RTCA Special Committee 209

ATCRBS / Mode S Transponder MOPs Maintenance

Meeting #11

**P5 Pulse Position Differences
Between
DO-181D and Annex 10 Vol. IV / ED-73C**

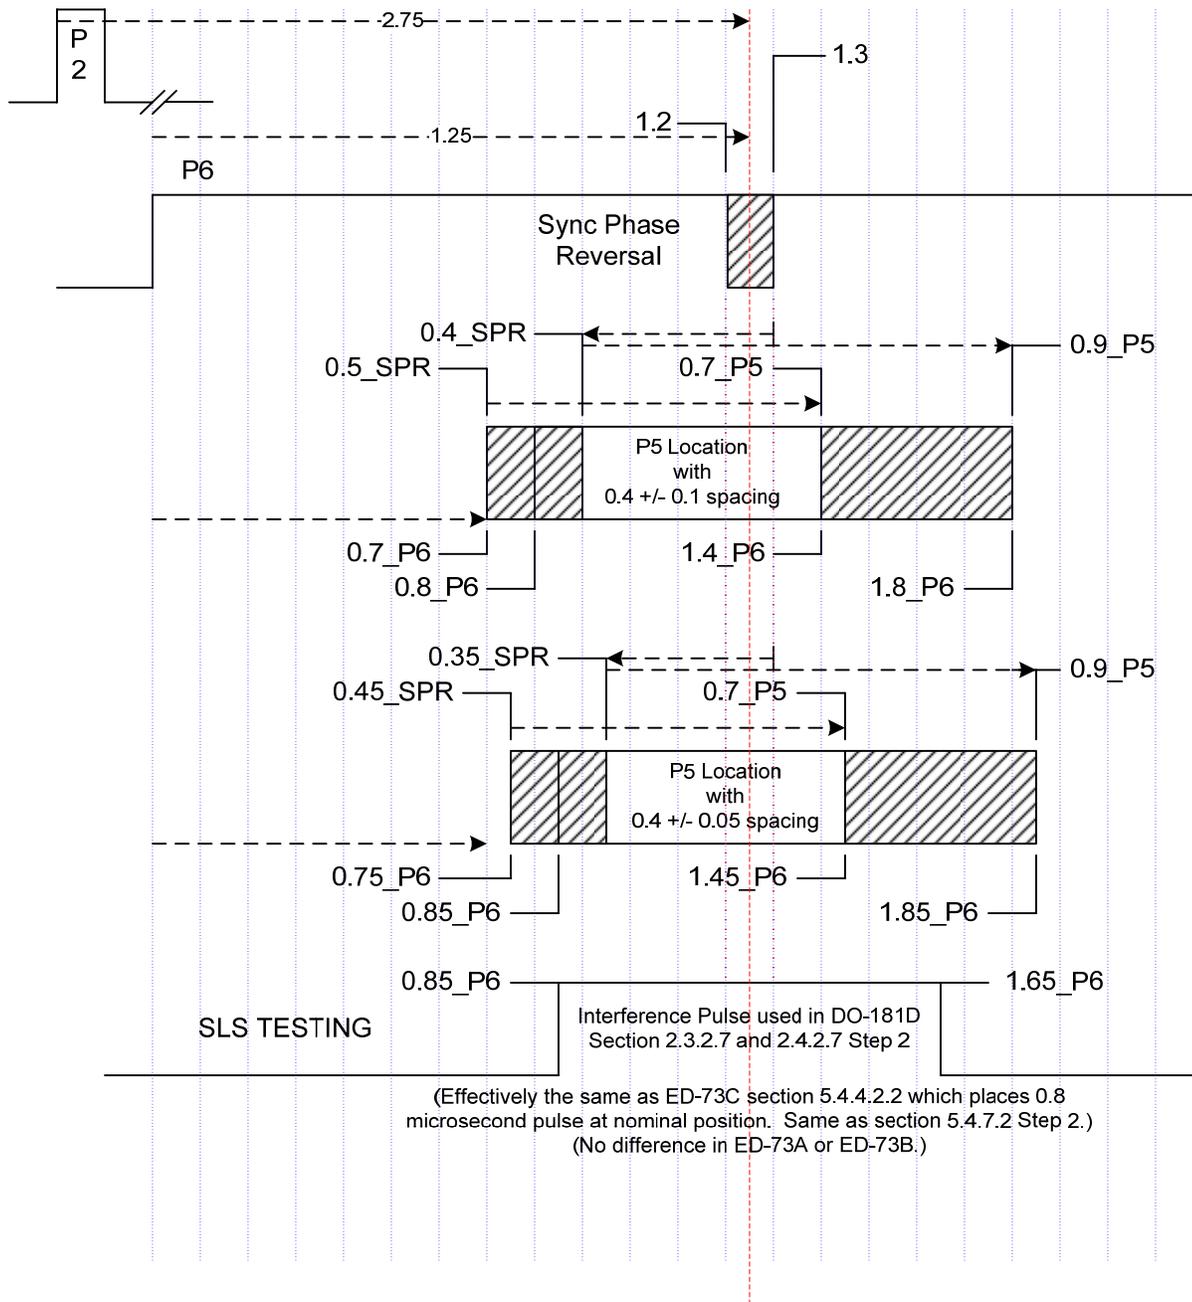
The following figure illustrates the worse case pulse positions possible for both the 0.4 +/-0.5 microsecond and for the 0.4 +/- 1.0 microsecond spacings. As shown, both conditions will easily ensure that the P5 position will properly obscure the sync phase reversal and thereby cause non-acceptance of the Mode-S interrogation if the P5 amplitude is sufficient. The figure also illustrates that the same P5 pulse position is used for testing Mode-S SLS in both RTCA DO-181D and in Eurocae ED-73C.

Review of the figure above indicates that there probably is little functional difference when having a P5 position tolerance of +/- 0.1 or +/- 0.05 microseconds. Either case will properly mask the sync phase reversal.

Considering that the ICAO documents appear to have always used a tolerance of +/- 0.05 microseconds, the recommendation is to change the RTCA DO-181D spacing to be the same as ICAO Annex 10. That is, **change** RTCA DO-181D section 2.1.11.4.4 to specify a **P5 to sync phase reversal spacing of 0.40 +/- 0.05** microseconds. There is no impact to the current test procedure provided in either RTCA DO-181D or Eurocae ED-73C.
